City of Santa Fe, New Mexico

memo

2025-011244-HDRB, 412 Camino Cabra, Downtown & Eastside Historic District, Contributing, Ju Tan, agent for Heather Lundine and Tom Wilmoth, owners, request approval for window replacements, construct a coyote fence to a height of 4'-6", and a yard wall to a height of 3'-9" where the maximum allowable is 5'-1". Two exceptions are requested to 14-5.2(D)(1)(a) removal of historic material and 14-5.2(D)(5)(a)(i) historic windows shall be repaired or restored wherever possible.

Figure 3. Proposed East Elevation.

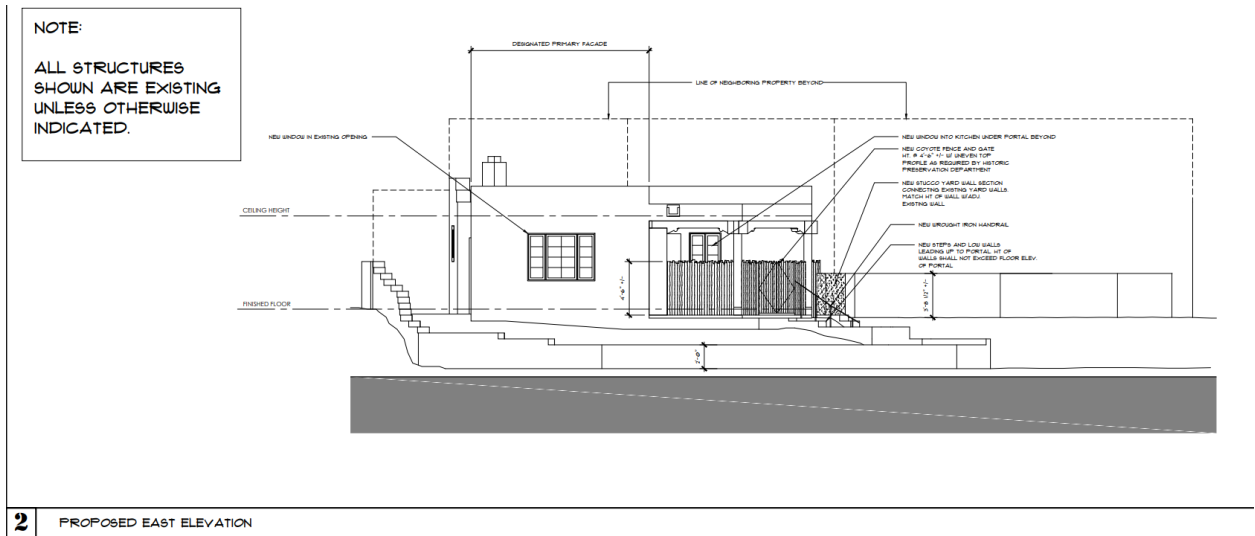
Exception to 14-5.2(D)(1)(a) removal of historic material: The applicant requests an exception to remove a historic four-over-four steel casement window on the east primary façade with an aluminum-clad window in a similar appearance and dimension.

Staff Response: Staff finds that this criterion is not met. Staff has evaluated the applicant’s response, and the replacement of the steel casement window will change the character of the facade. Furthermore, cut sheets or details of the proposed windows were not provided, which impacted the staff’s ability to judge the overall visual impact.

Staff Response: Staff finds that this criterion is not met. Staff has evaluated the applicant’s response and finds that the replacement of the steel casement window with the Kolbe Vistaluxe WD aluminum-clad window does not sufficiently duplicate the style of the historic window. The burden of cost is not a criterion; furthermore, it is the public’s expectation through the

Staff Response: Staff finds that this criterion is not met. Staff has evaluated the applicant's response and finds that the replacement of the steel casement window with the Kolbe Vistaluxe WD aluminum clad window will impact the character of the primary facade. The applicant has described several options and researched multiple windows; there is not enough evidence that the replacement window will be in-kind.

Staff Response: Staff finds that this criterion is not met. Staff has evaluated the applicant's response and finds that the proposed replacement window is hard to evaluate, give no specific product information was provided.

Staff Response: Staff finds that this criterion is not met. Staff has evaluated the applicant's response and finds that restoring one window out of 7 being proposed for replacement does

Staff Response: Staff finds that this criterion is not met. Staff has evaluated the applicant's response and finds that, while design options were considered, no analysis was provided on what measures can be implemented to restore the existing historic window. Staff has no objection to all other windows being replaced on the residence. Finally, no product material or cut sheets were provided to enable staff or the HDRB to evaluate whether there would be a significant change to the overall appearance of the window.
